Application – CRC 190445 – by the Christchurch City Council for Comprehensive Resource Consent to discharge storm water from with-in the Christchurch City area on or into land into water and into coastal environments.

Submitters - A D Rodrigues and K F Rodrigues response to applicants additional information

Date-21-02-2019

(Map B)

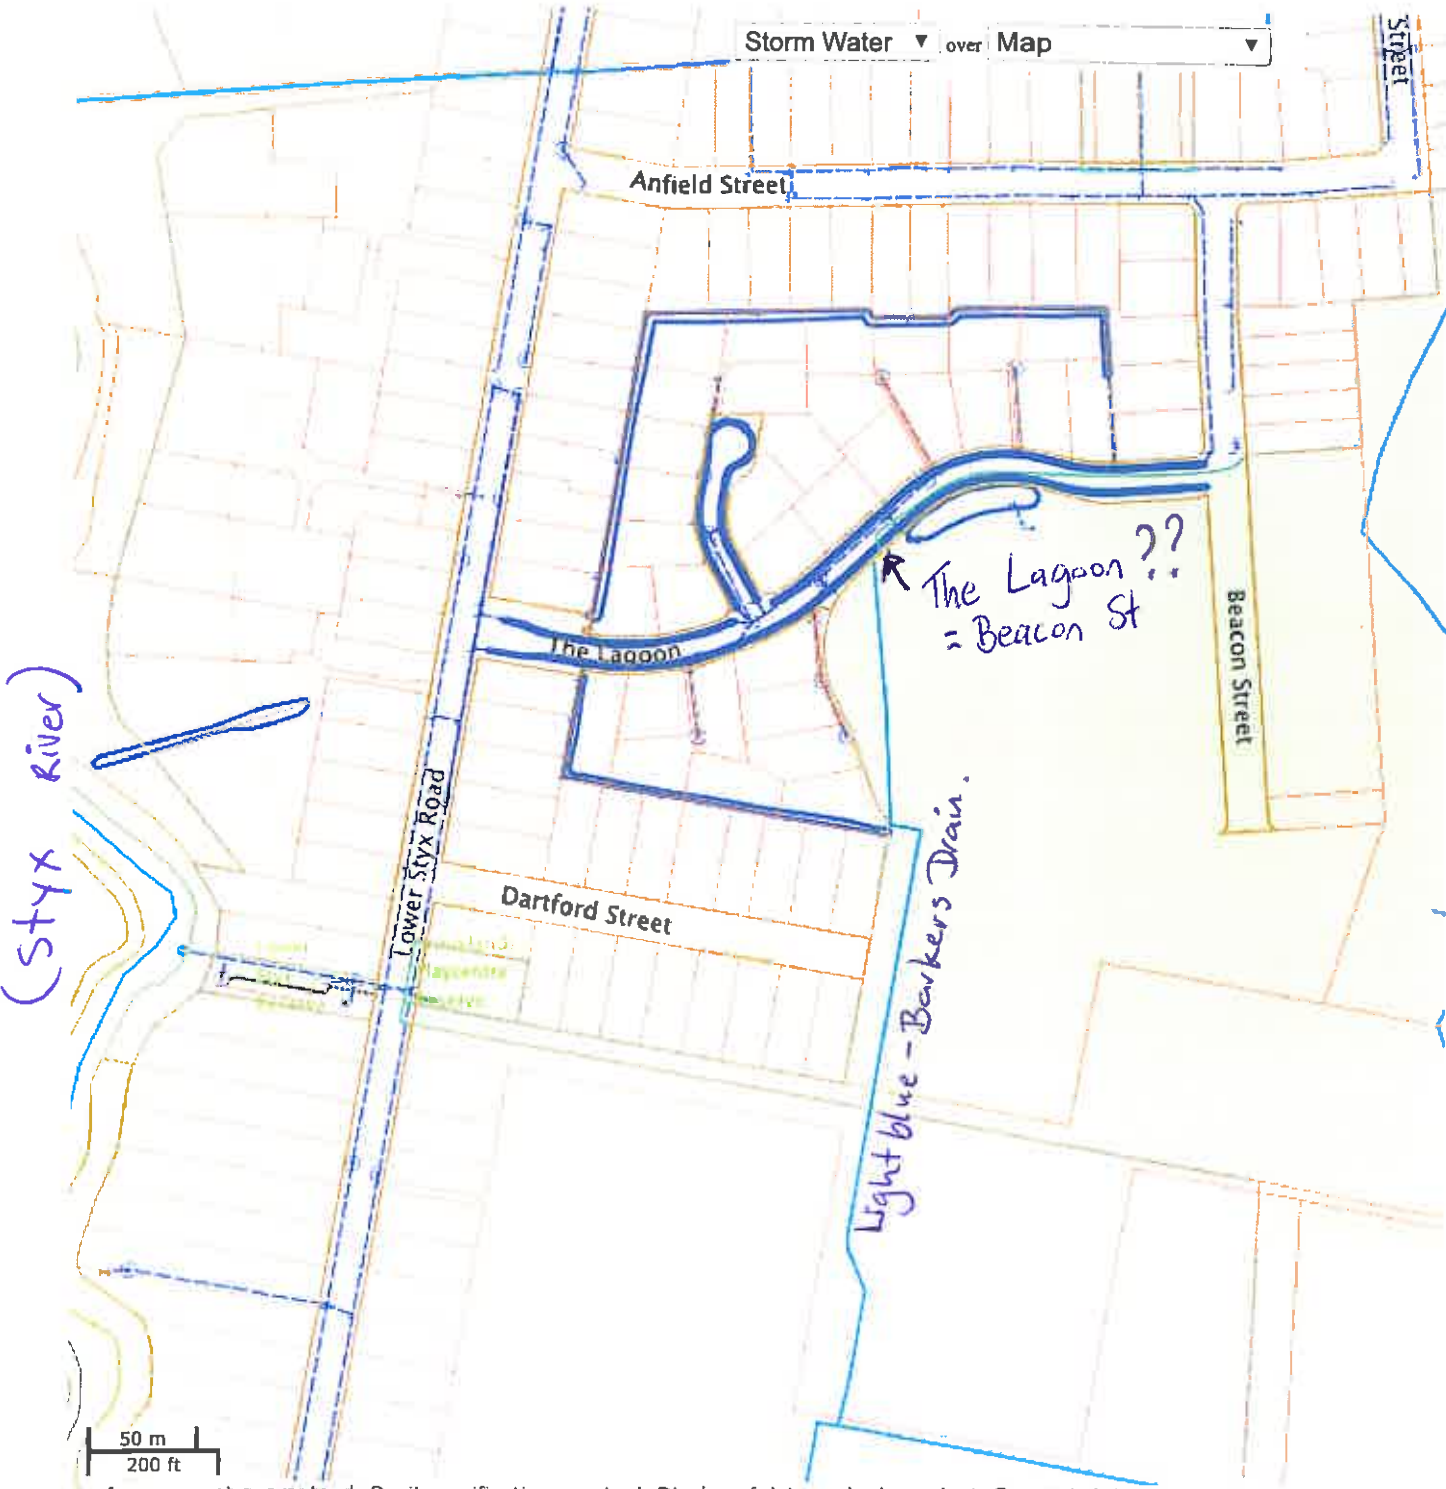
It had a series of 1 to 5 drain branches that ran from the Barkers drain towards the Lagoon with only one branch reaching the Brooklands Lagoon and the main Barkers Drain goes up towards Beacon Street which on map A,B,C & D (provided) is a street called “The Lagoon” There appears to be an outlet opposite to the Lower Styx River. Please see attached Christchurch City Drainage Maps A,B & D.

Figure 9 2015 LiDAR survey data (overland flow paths shown with red arrows and Barkers Drain shown in blue)

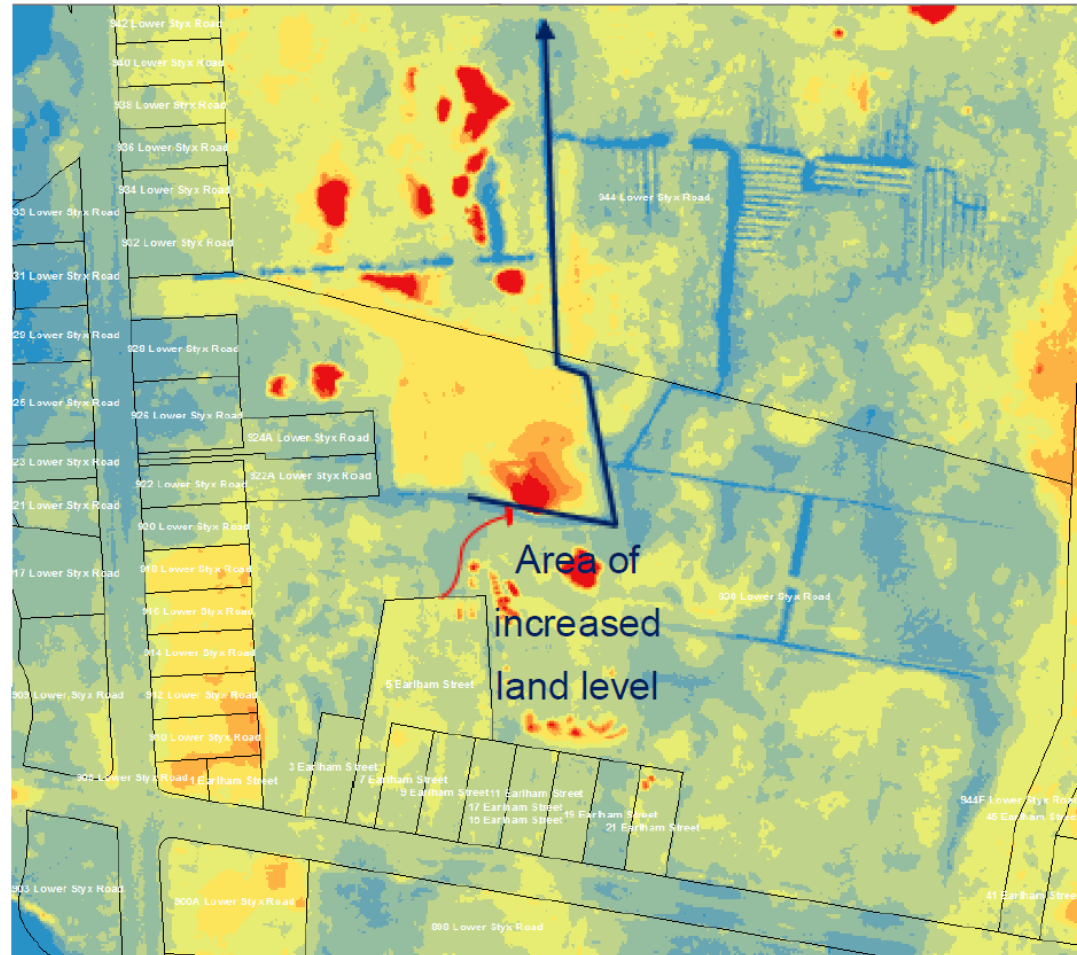
You will see on page 22 of the Joint Statement by the Christchurch City Council and Mr Rob Potts a diagram of Barkers Drain dated 2015. This diagram is not showing a true representation of what Barkers Drain network was pre earthquake and fill and that is misleading.

Please see diagram on page 22 of the Joint Statement (our attachment called Barkers drain diversion) – the lighter blue lines show the 2015 diversion done by neighbours and that is why his trees died due to the back flow of the Brooklands Lagoon.

We would like an explanation about the dark blue line that is shown in the Joint statement on page 22.

Please see above as at 2015 (dark blue line Barkers Drain) (light blue lines =diversion of Barker Drain)???
